Consider and approve Change Order No. 4 for KBR - Cedar Breaks Road.

CHANGE ORDER NUMBER: 4

Project: 02WC422
 Roadway: Cedar Breaks
 Purchase Order Number: _____

Project: 02WC422
Roadway: Cedar Breaks Road
Re: Change Order No. 4

SCALE: 1"=50'	SHEET 1 OF 5
DES: HAS	SHEET
CK DES: DJW	WILLIAMSON COUNTY
DRN: MDH	JOB NO. WC 1055
CK DRN: AJR	28A

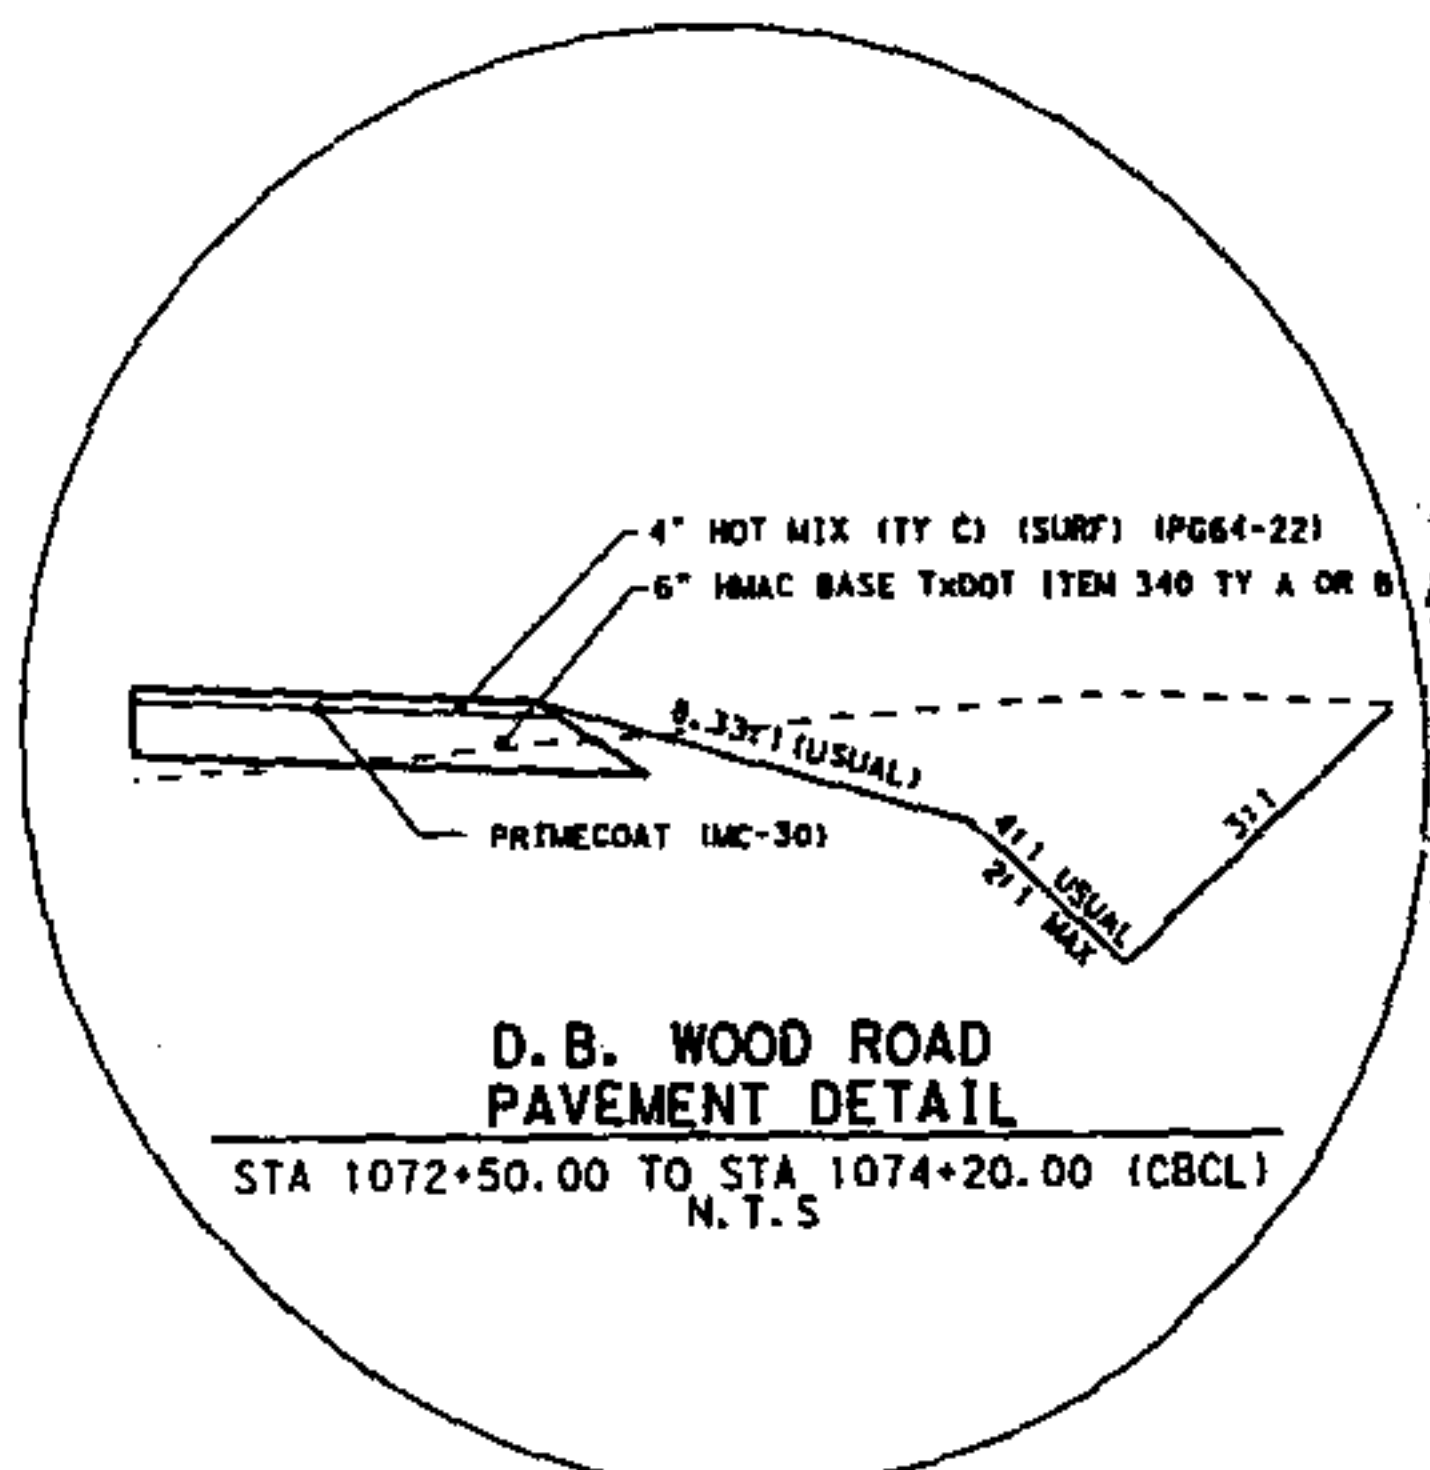
Provide compensation for changes in striping to properly accommodate the new Shell road alignment (City of Georgetown), it has been necessary to change/modify the lane configuration in the vicinity of this intersection (Sta. 155+00 to 127+38). Compensation for special excavation at sink hole as recommended on ACI consulting report item no. 2 (Sta. 85+00). Compensation for additional drive ways and drainage pipes with SET not included in original plans (sta. 20+00, 20+20 and 1086+88), and gate relocation (sta. 20+20) to adjust entrance due to change in grade of existing driveway. Compensation for the 6" HMA to allow construction of tie in points at sta. 15+50 to 18+65 and sta. 1072+50 to Sta. 1074+20. Removal of concrete driveways and construction of concrete driveways.

NOTE: STA 1072+50.00 TO STA 1074+20.00 BUILD UNDER TRAFFIC
UTILIZING TCP STANDARD 1-2, FIGURE TCP 1-20
CONTRACTOR WILL USE TCP (7-1)-98 AT THE END
OF THE WORK DAY

SCALE: 1" = 50'		SHEET 1 OF 1	
DES: HAS	WILLIAMSON COUNTY JOB NO. WC 1055	SHEET	
CK DES: AJR		40	
ORN: HAS			
CK ORN: AJR

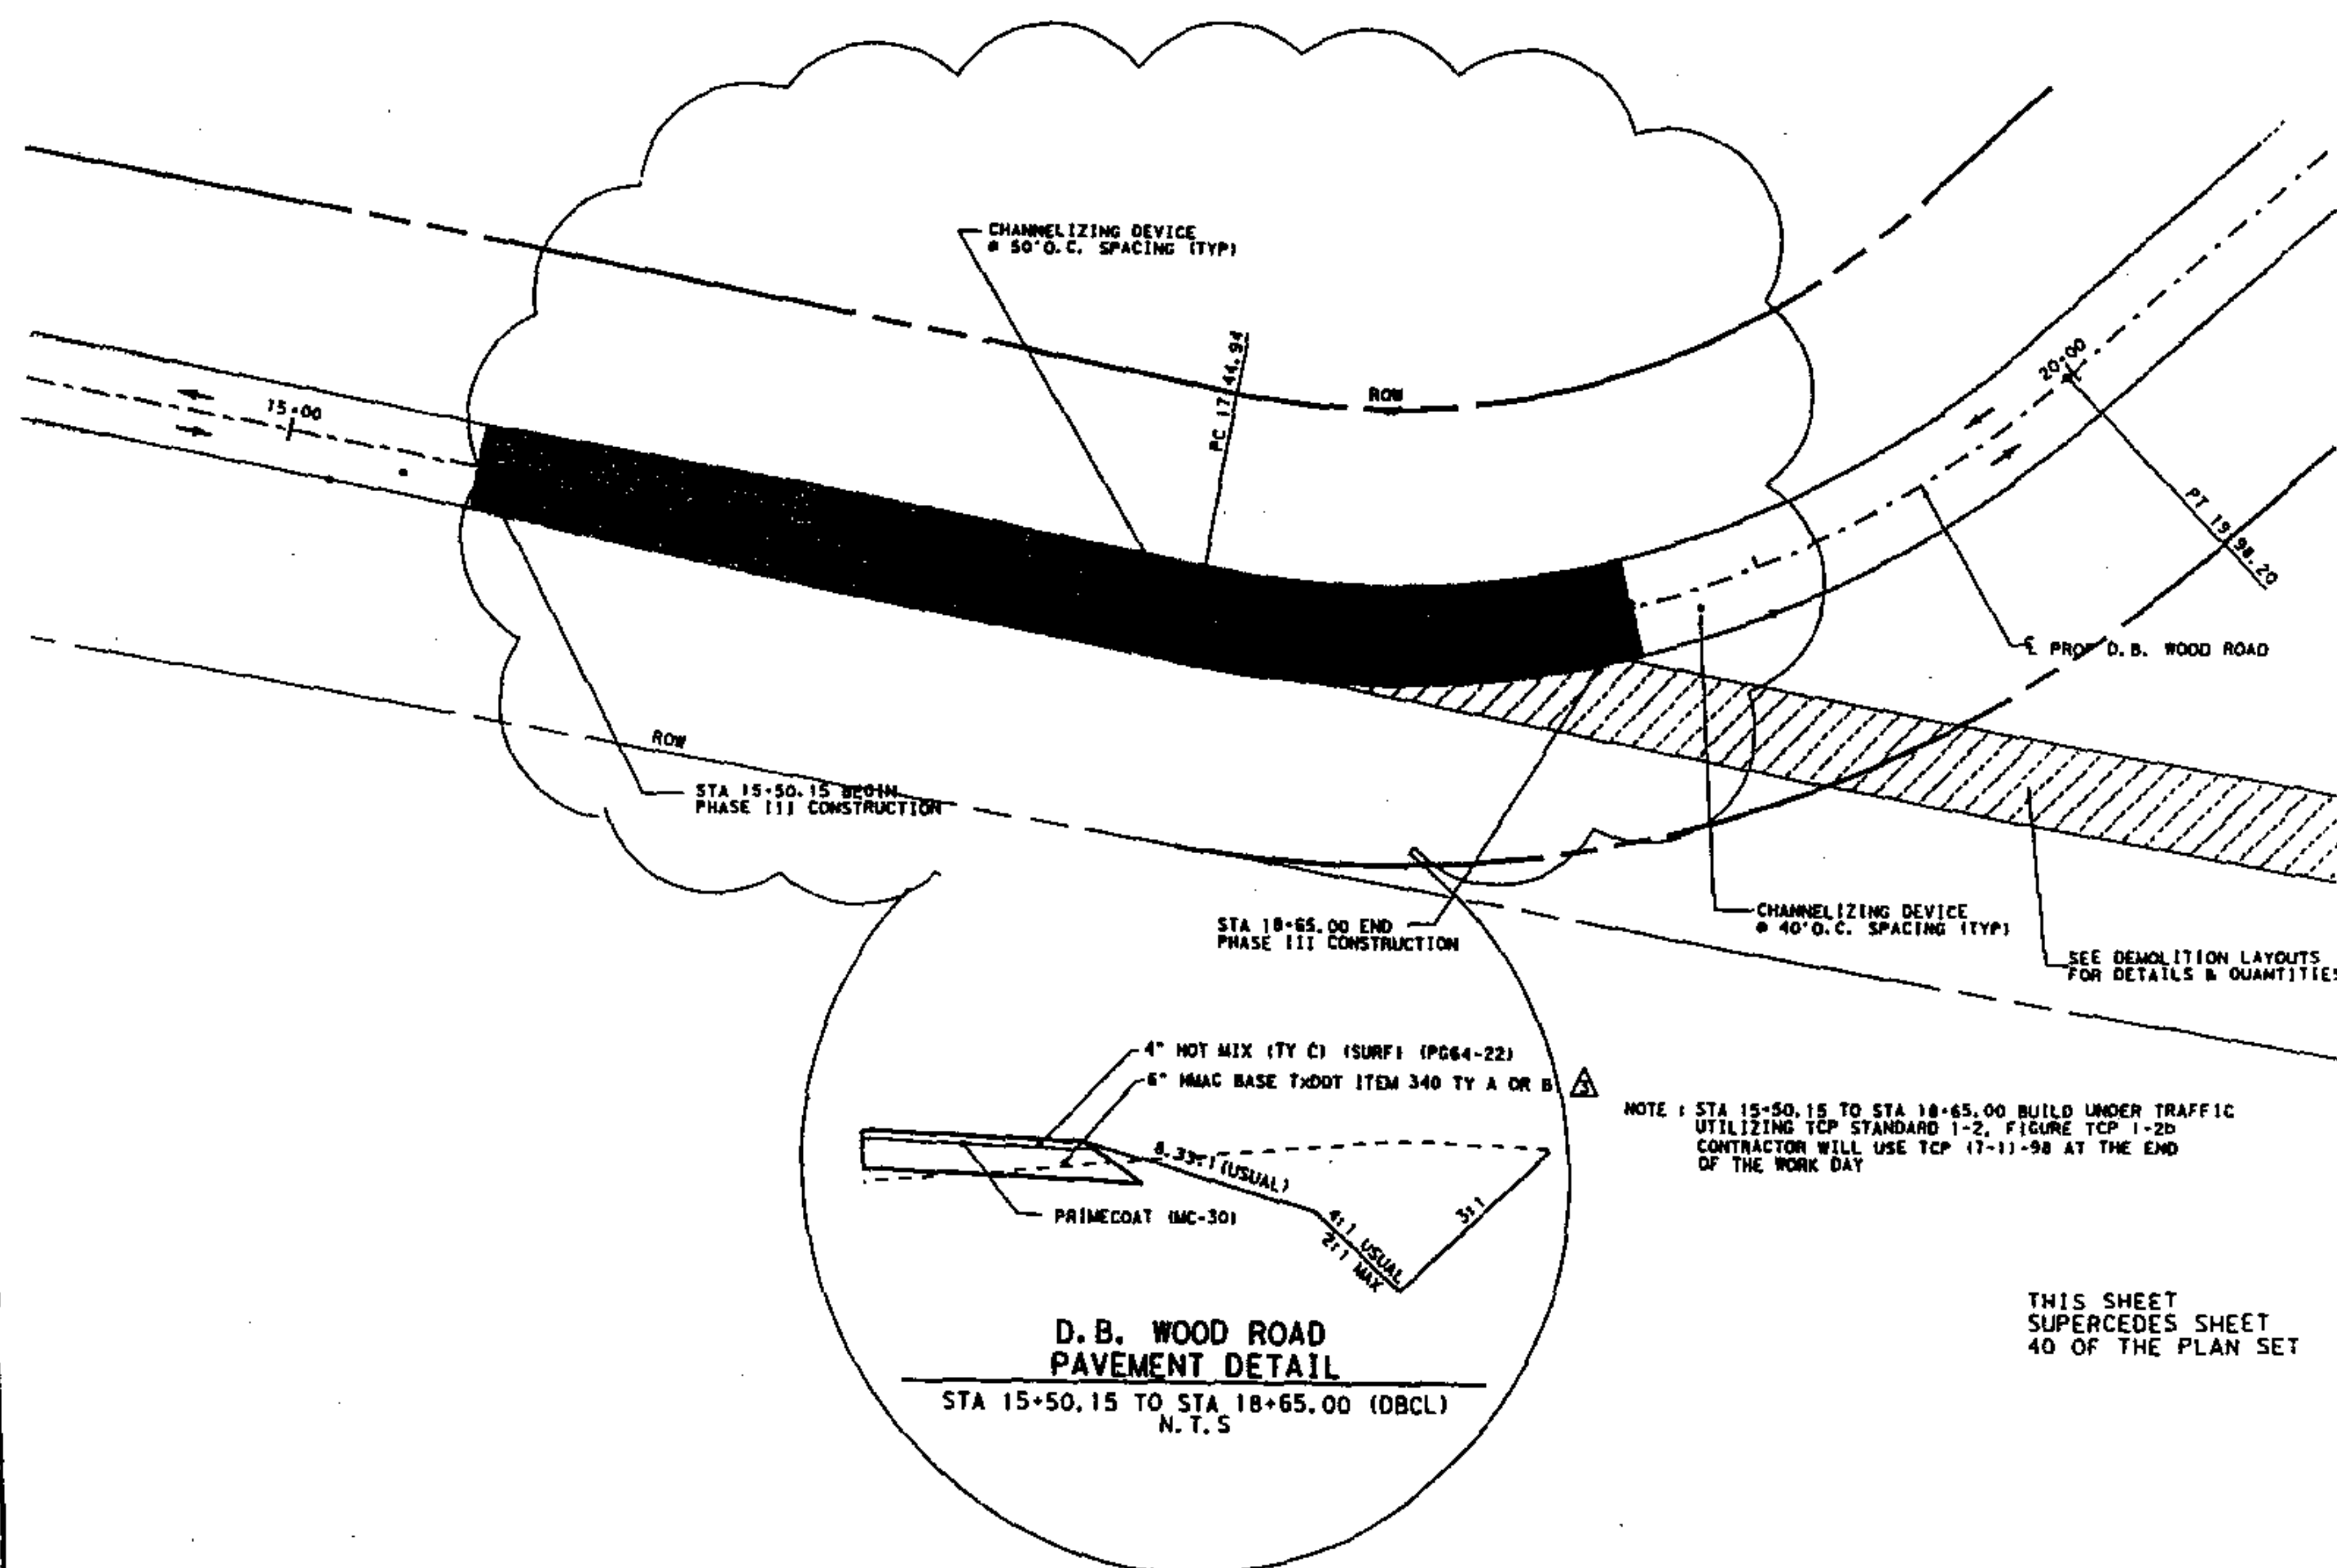
THIS SHEET
SUPERCEDES SHEET
40 OF THE PLAN SET
